PRODUCT ADVISORY

**Data Sheet Specification Change for
Intersil Products ISL59601*,
ISL59602*, ISL59603*, ISL59604*,
and ISL59605***

**Refer to:
PA12072**

Date: September 6, 2012

FIGURE 45. APPLICATION CIRCUIT FOR UTP CABLE

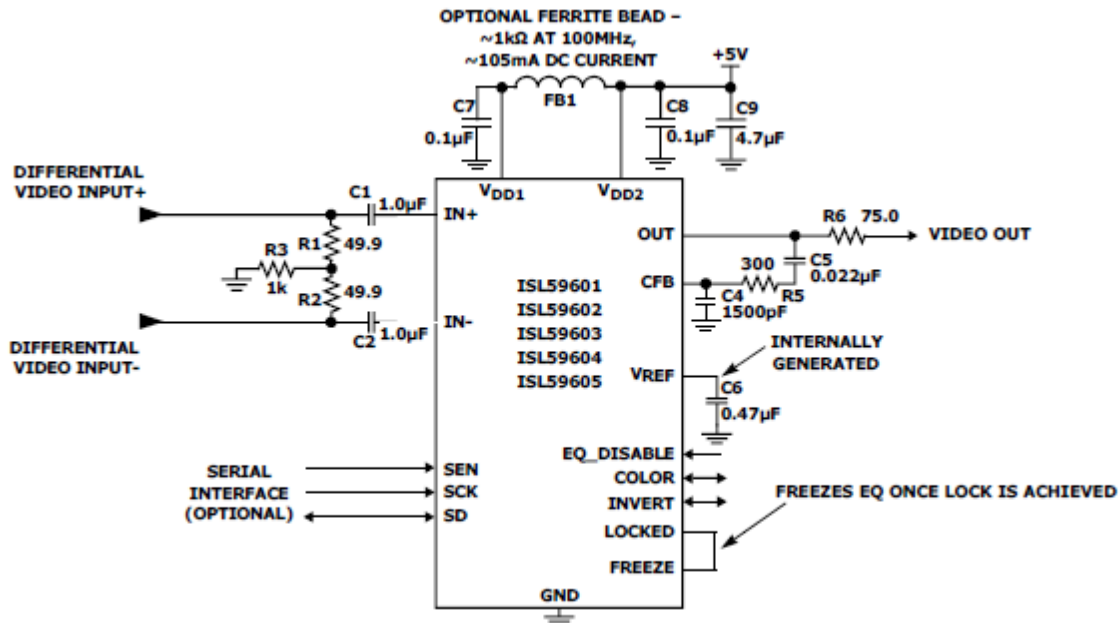
- Figure 45 – Application Circuit for UTP Cable (Page 20):

Change From:

FIGURE 45. APPLICATION CIRCUIT FOR UTP CABLE

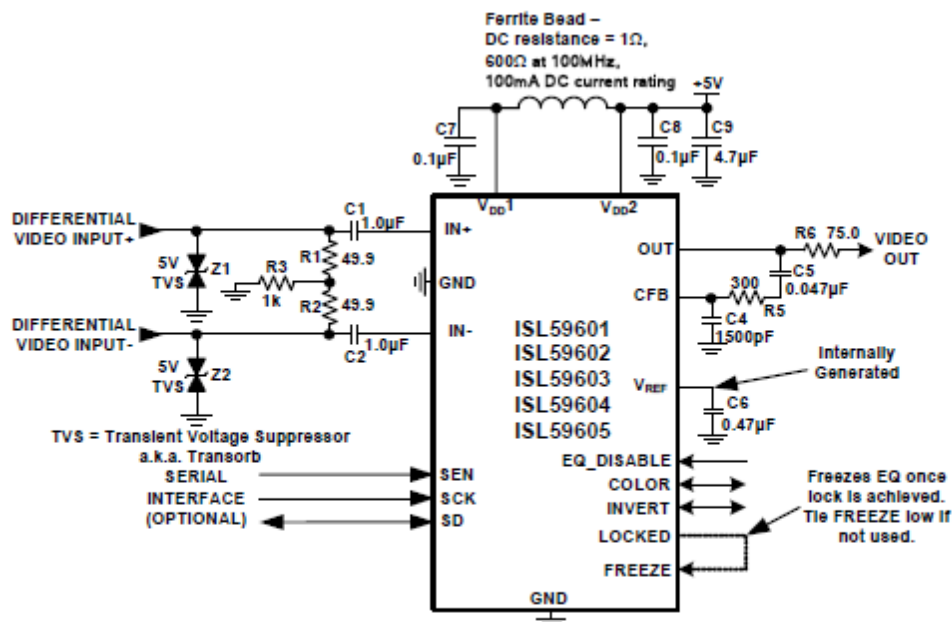
Change To:

FIGURE 46. APPLICATION CIRCUIT FOR COAX CABLE

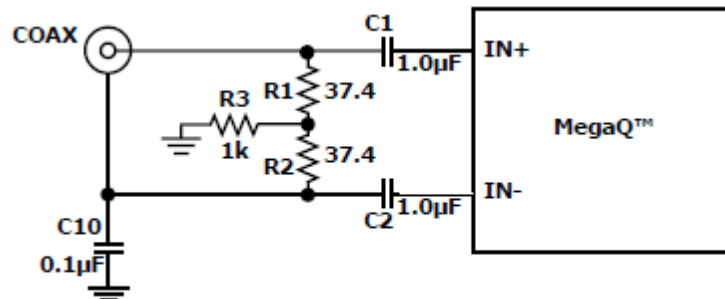
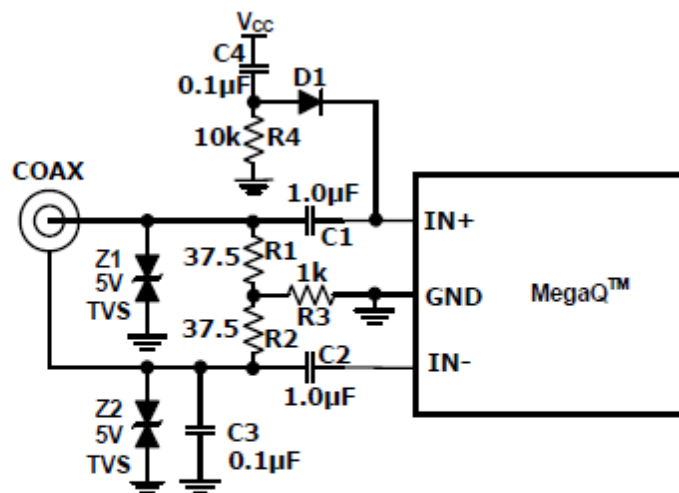
- Figure 46 – Application Circuit for COAX Cable (Page 21):

Change From:

Change To:

TVS = Transient Voltage Suppressor
a.k.a. Transorb

FIGURE 47. APPLICATION CIRCUIT FOR COAX CABLE

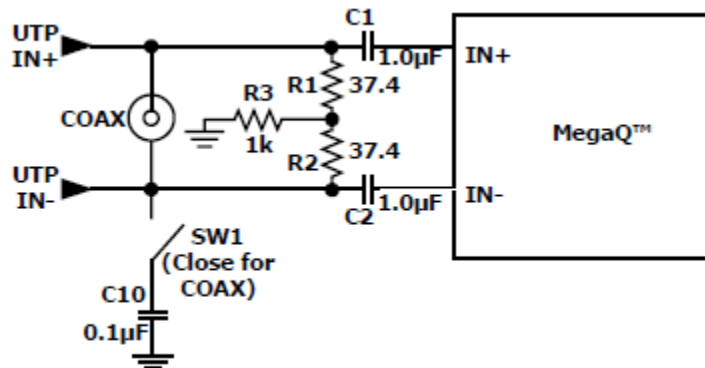
- Figure 47 – Application Circuit for UTP/COAX Cable (Page 21):

Change From:

FIGURE 47. APPLICATION CIRCUIT FOR UTP/COAX CABLE

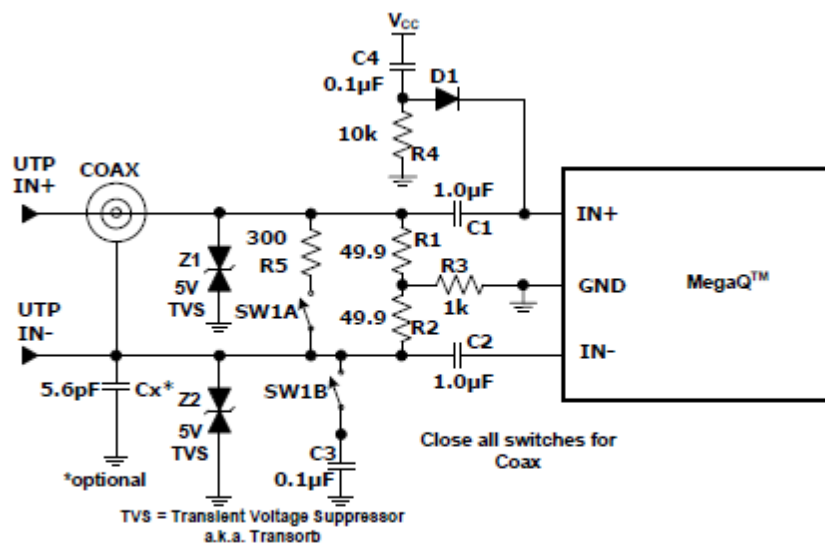
Change To:
